Final Environmental Assessment

**Grand Junction
Conversion
Transmission Line
Project**

FINAL ENVIRONMENTAL ASSESSMENT
ON THE
GRAND JUNCTION CONVERSION TRANSMISSION LINE PROJECT
AND AN AMENDMENT TO THE
ROAN CREEK/WINTER FLATS MANAGEMENT FRAMEWORK PLAN

This document is an abbreviated FEA which means that it includes only corrections to the draft, comment letters with responses, and additional analysis which was conducted subsequent to the DEA in response to public and agency comments.

Figure 2-6 Revised

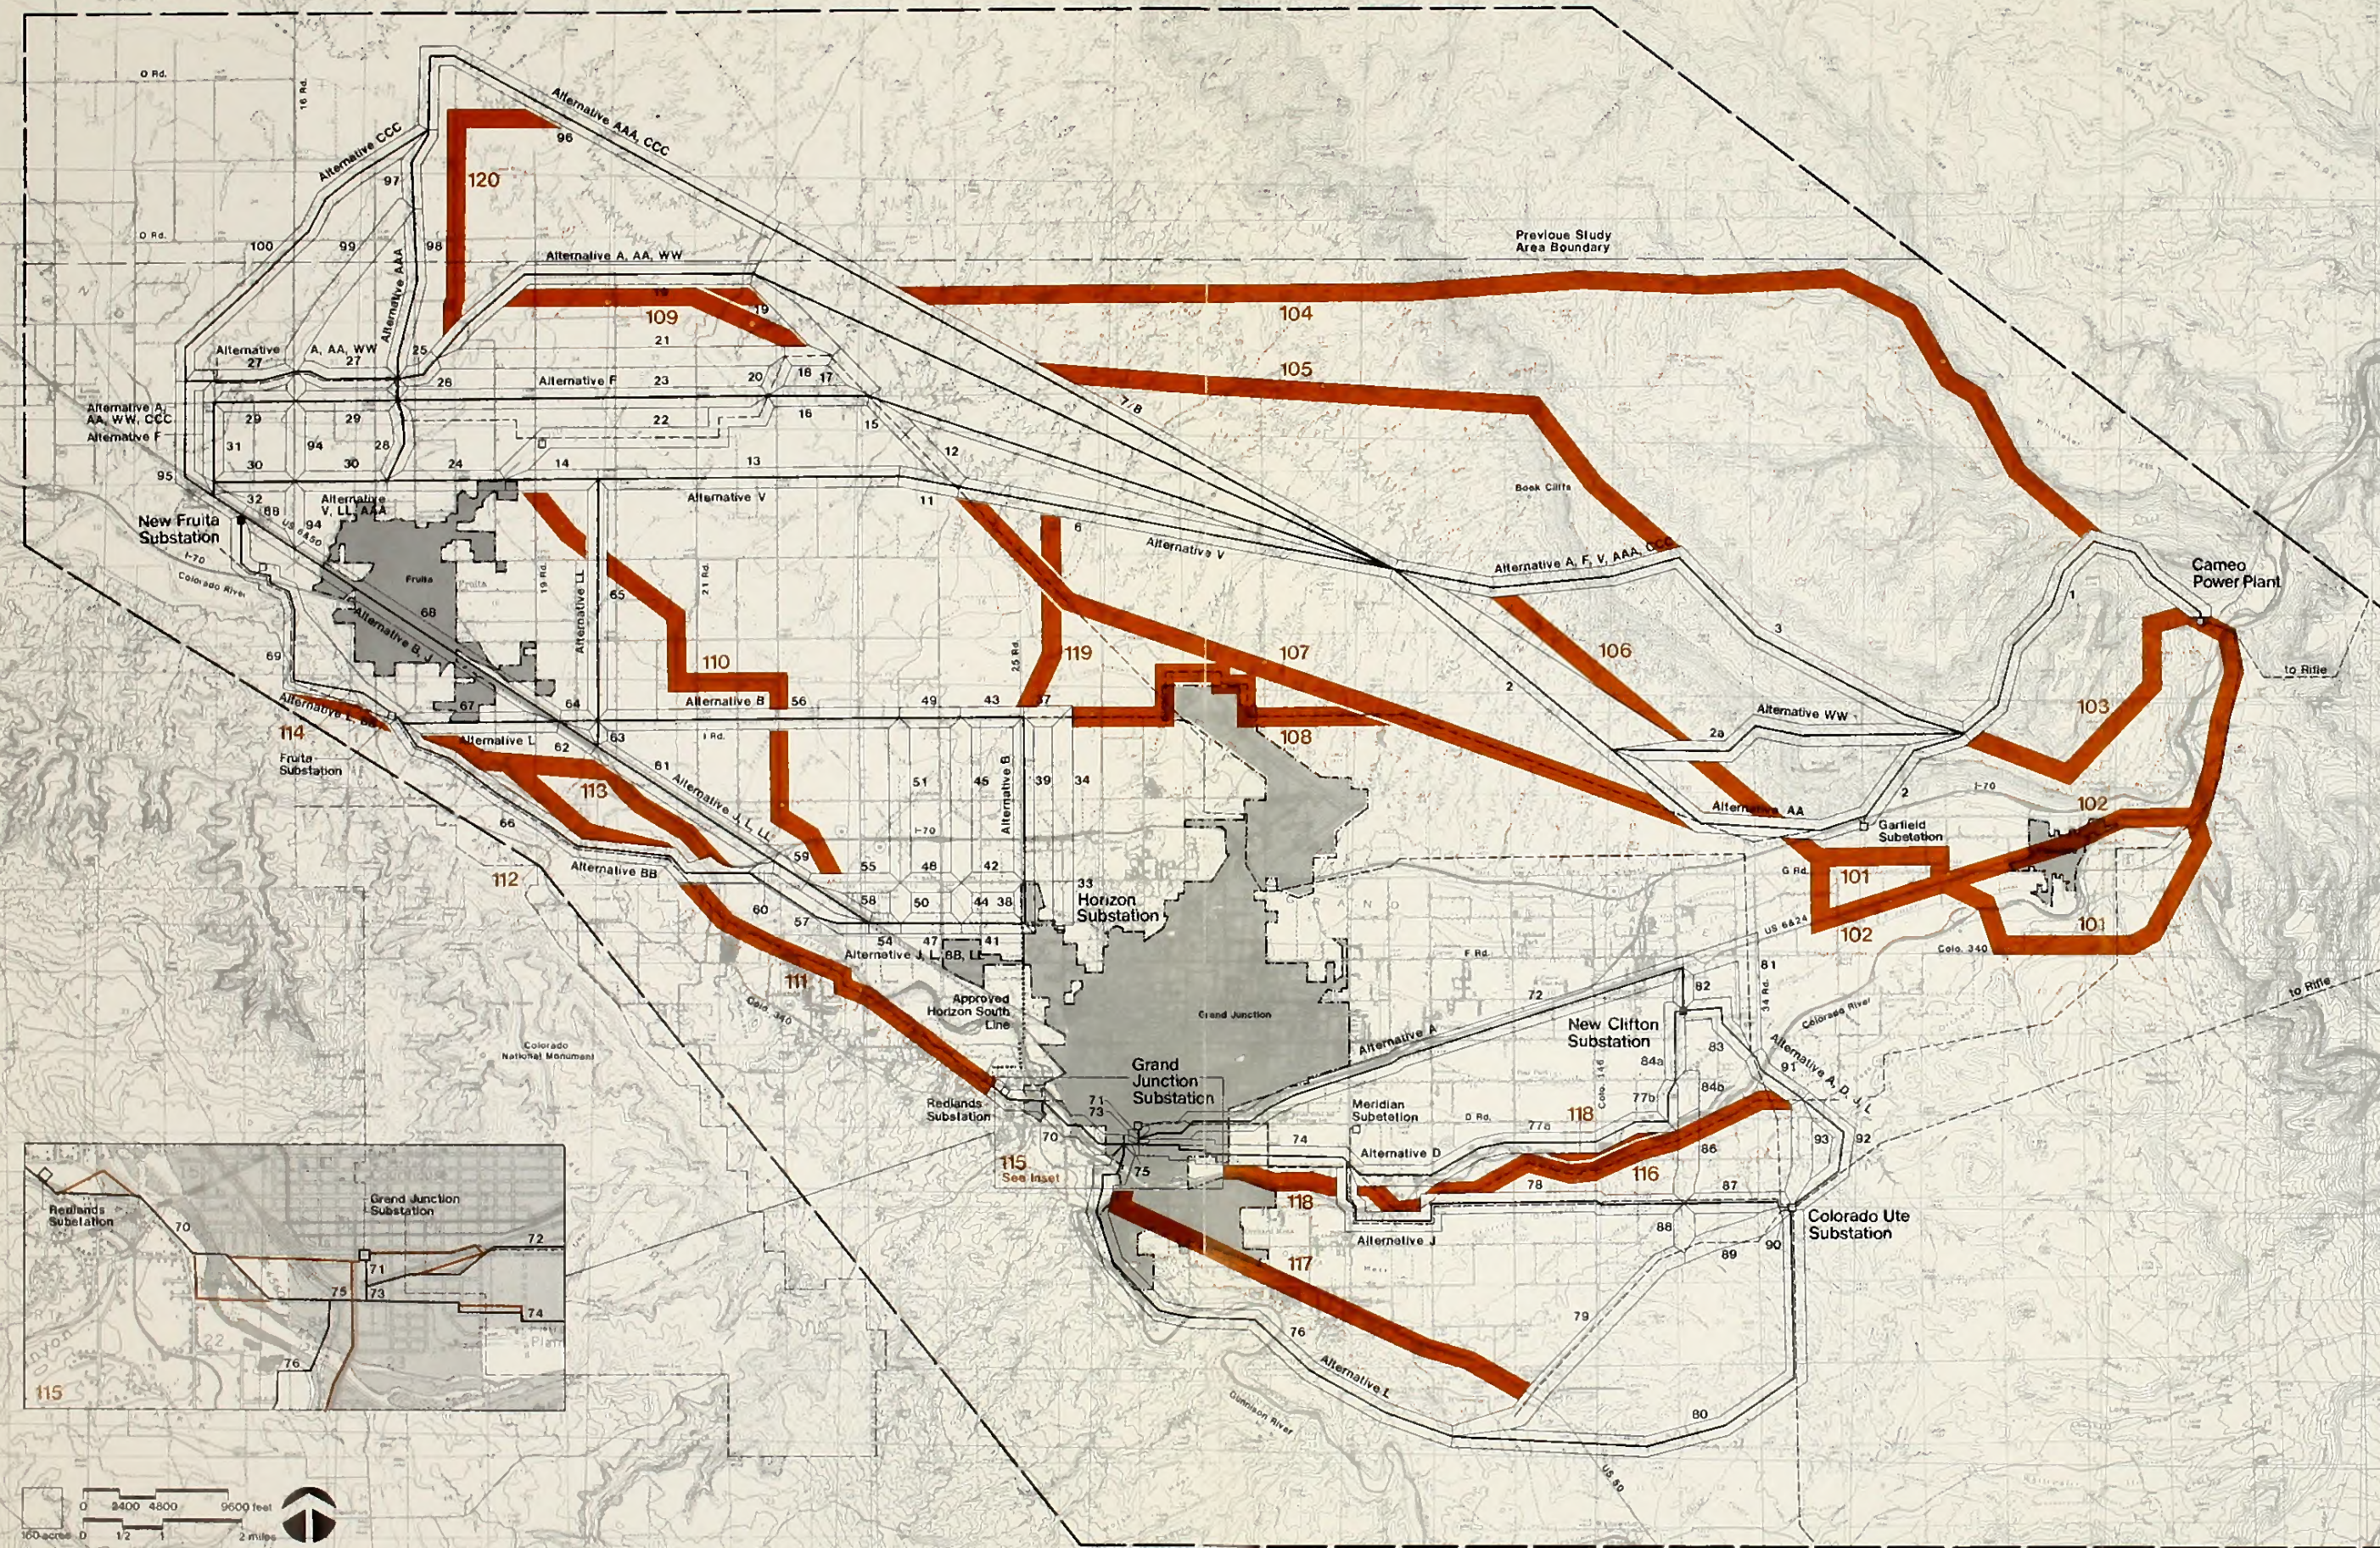
The following discussion pertains to routing opportunities that were considered early in the study process or were re-analyzed or considered after comments were received on the DEA. Although they are shown on Revised Figure 2-6 as specific corridors, they should be considered representative of numerous configurations that were investigated to make a desired connection.

Replace **Alternatives 101 and 102** with the following:

Alternatives 101 and 102 -- These alternatives were an attempt to develop a southern route out of Cameo to avoid the Book Cliffs. Numerous variations of the routes shown on Revised Figure 2-6 were explored, but had significant limitations. Of primary concern was the high visibility of portions of these alternatives in DeBeque Canyon as seen from I-70 and the outlying Palisade area. This area is rated 'A' (highest) scenic quality by BLM and is considered to be visually sensitive. In addition, these alternatives would involve from two to four crossings of the Colorado River which would be a biological, as well as visual and engineering concern.

Figure 2-8 Revised

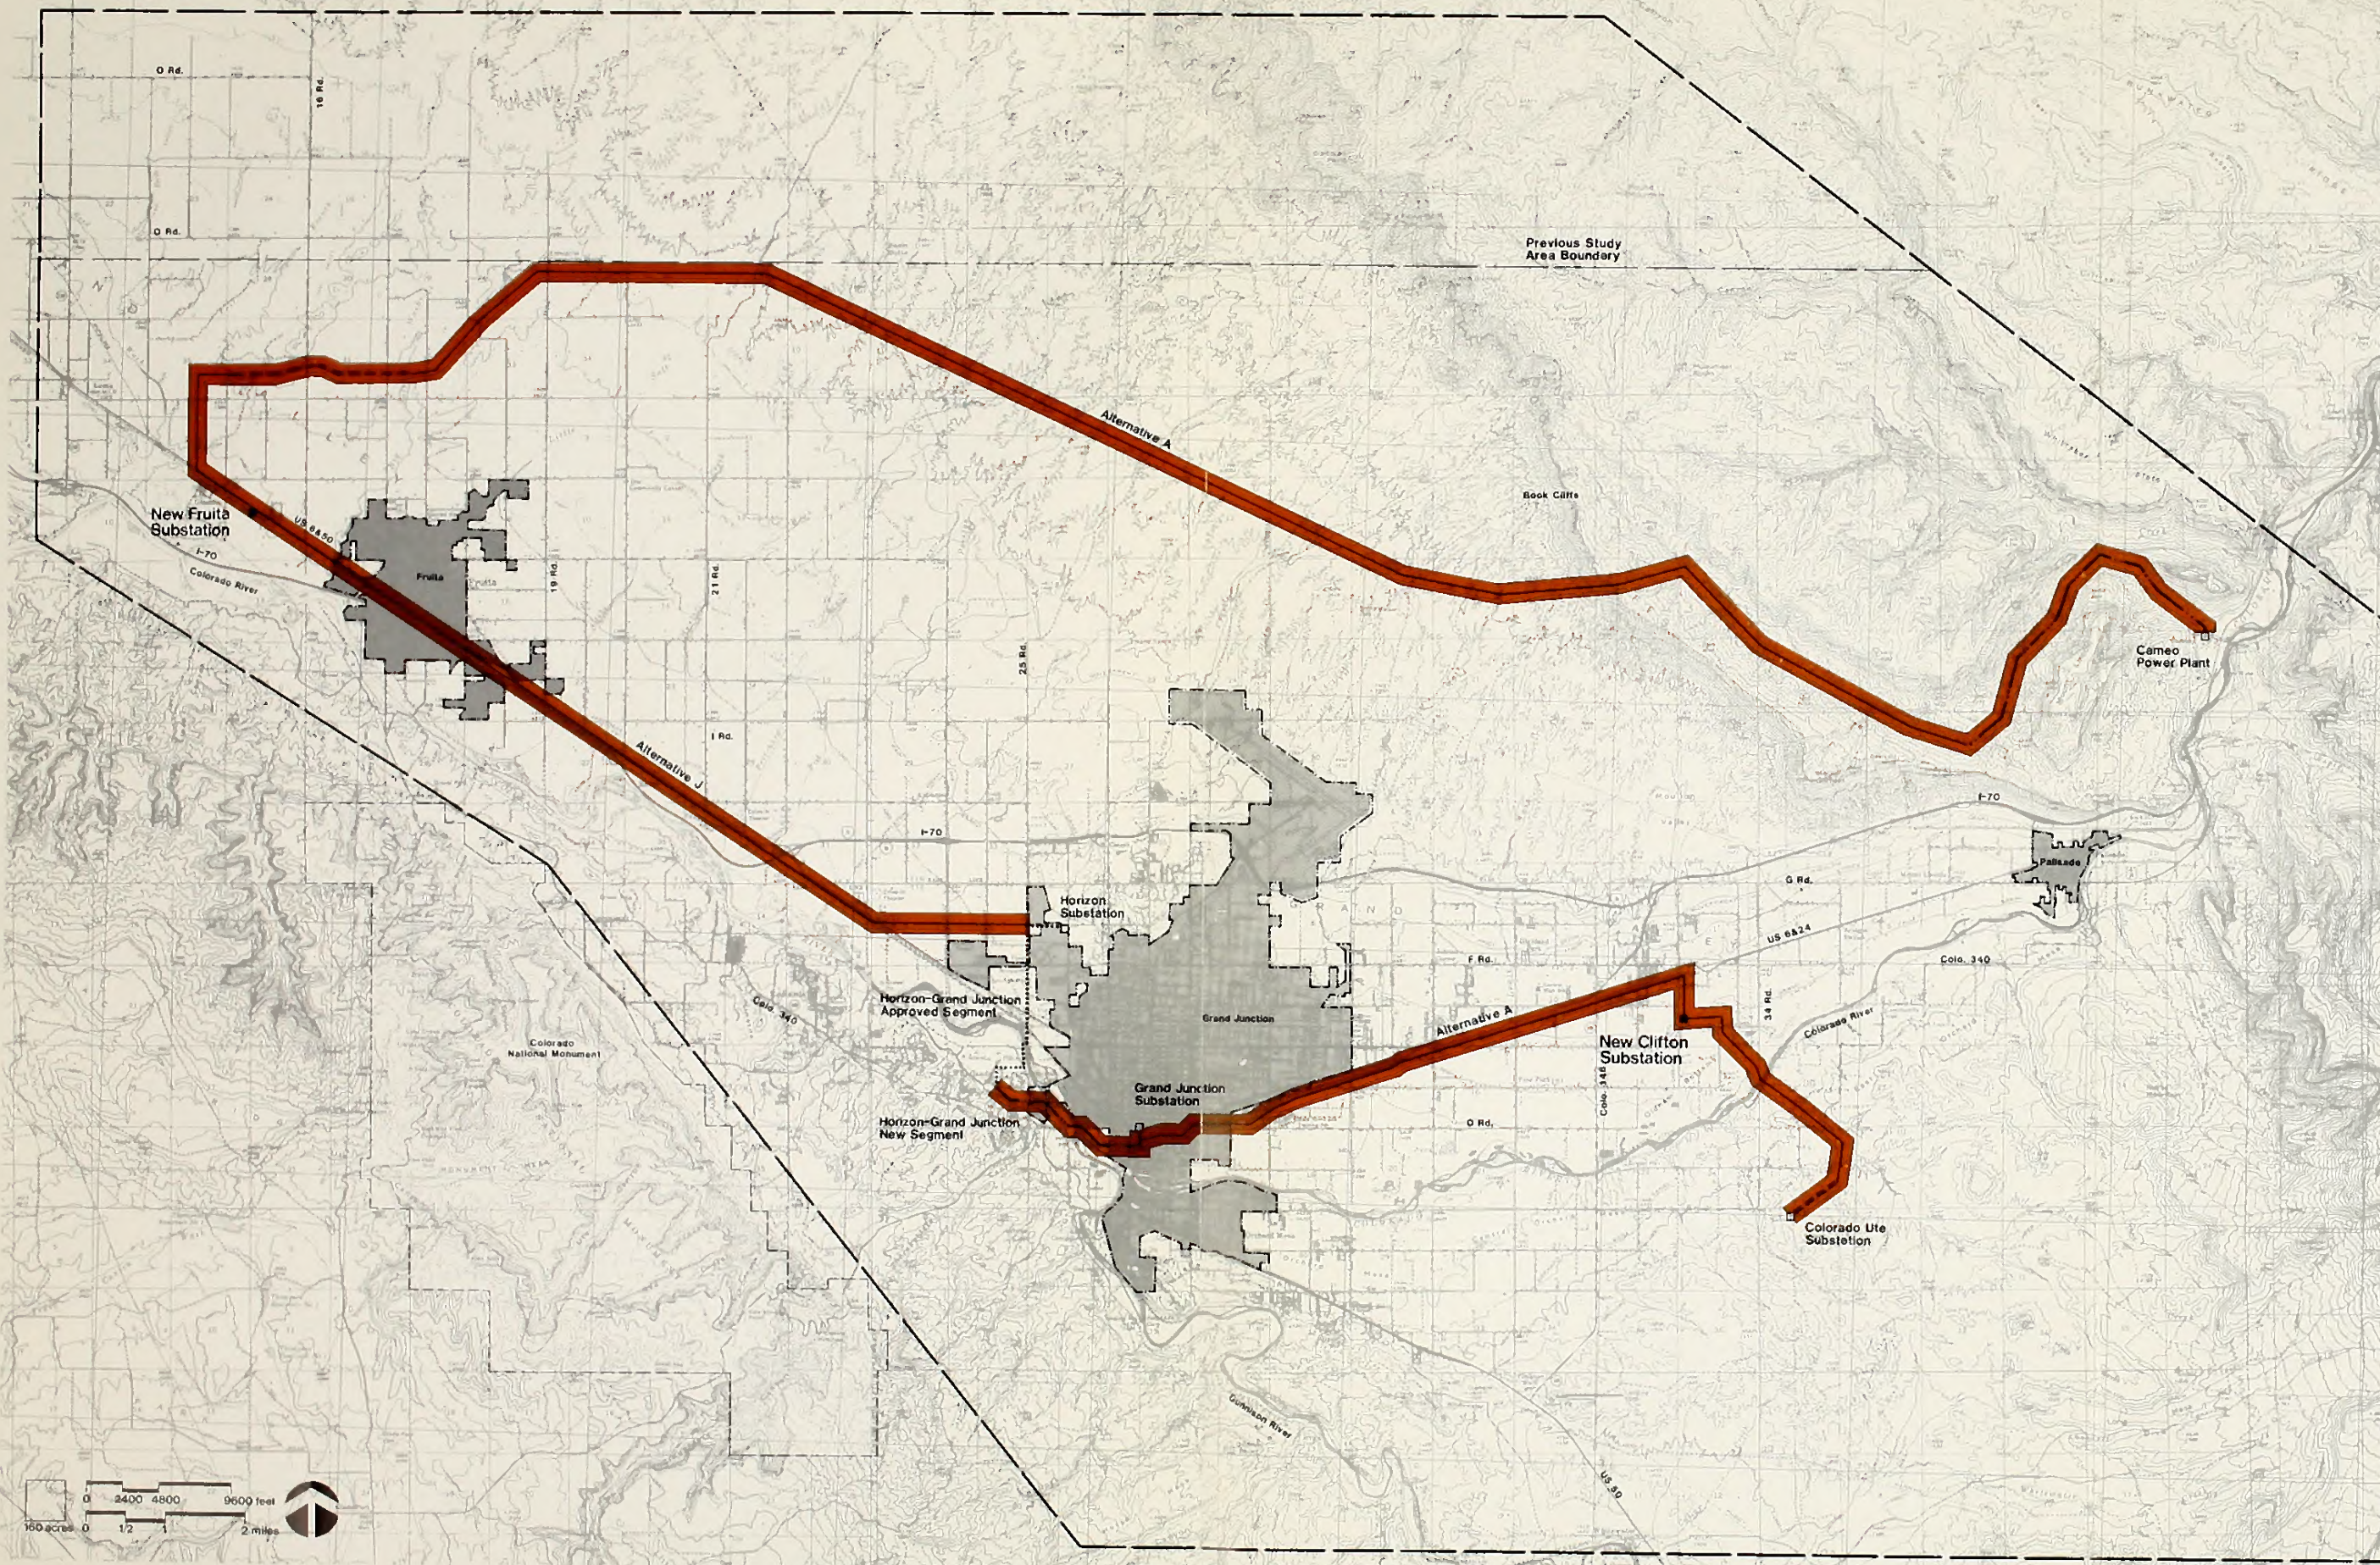
Replace Section **1, Description of the Proposed Action**, with the following:

The proposed action is shown in Revised Figure 2-8. As noted earlier, construction of the proposed action will result in the completion of a 230-kV loop to serve the Grand Junction area. Also included as part of the proposed action are the construction of two new substations, rebuilding the existing Grand Junction Substation, and adding equipment at two existing substations. The location of all these actions is shown in Revised Figure 2-8. A schedule of the proposed acquisition and construction related tasks described in the following sections of this chapter are shown on Revised Table 2-5, Construction Schedule.

Figure 2-9 Revised

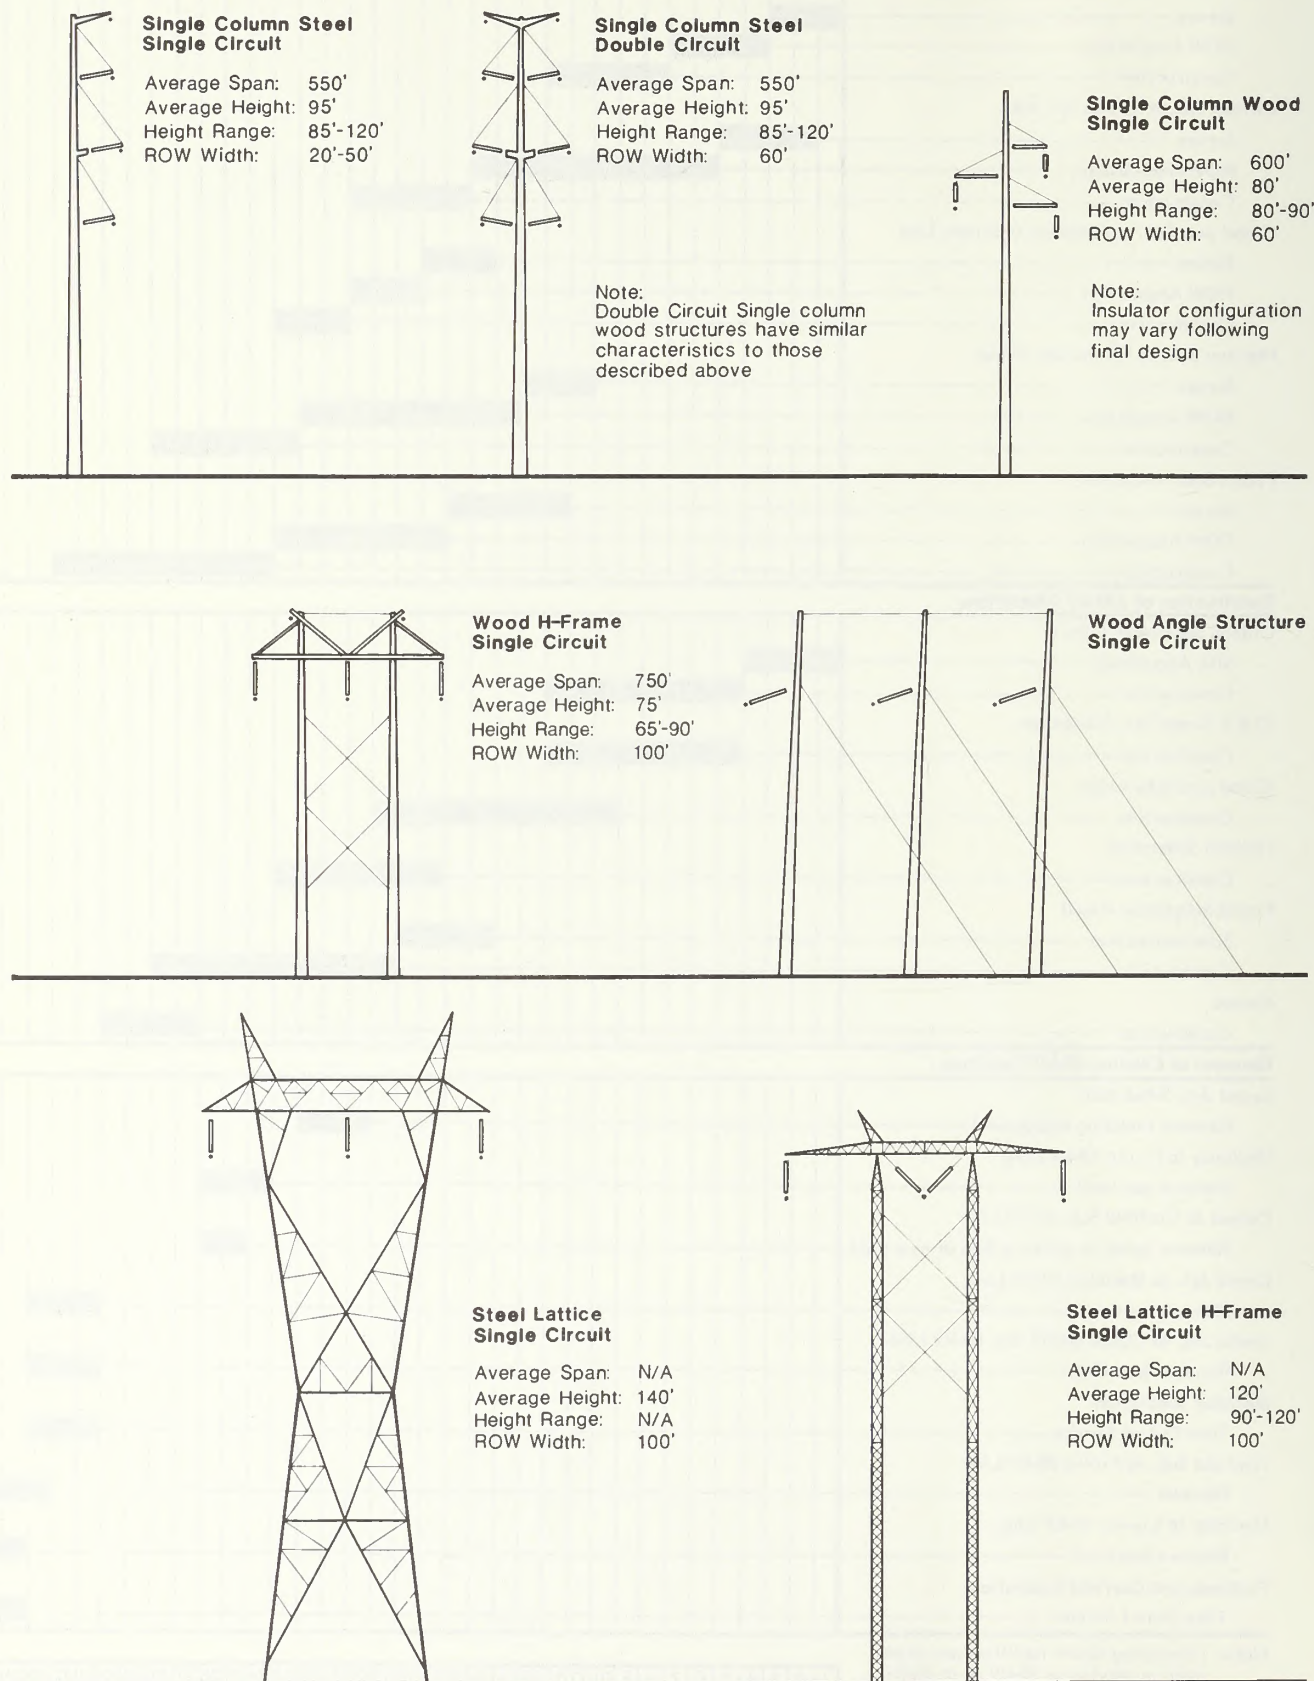
Replace the third paragraph with the following:

Revised Figure 2-9 shows scale illustrations for each structure that may be used. The types of structures that are most likely to be used for each segment are shown in Revised Figure 2-10.
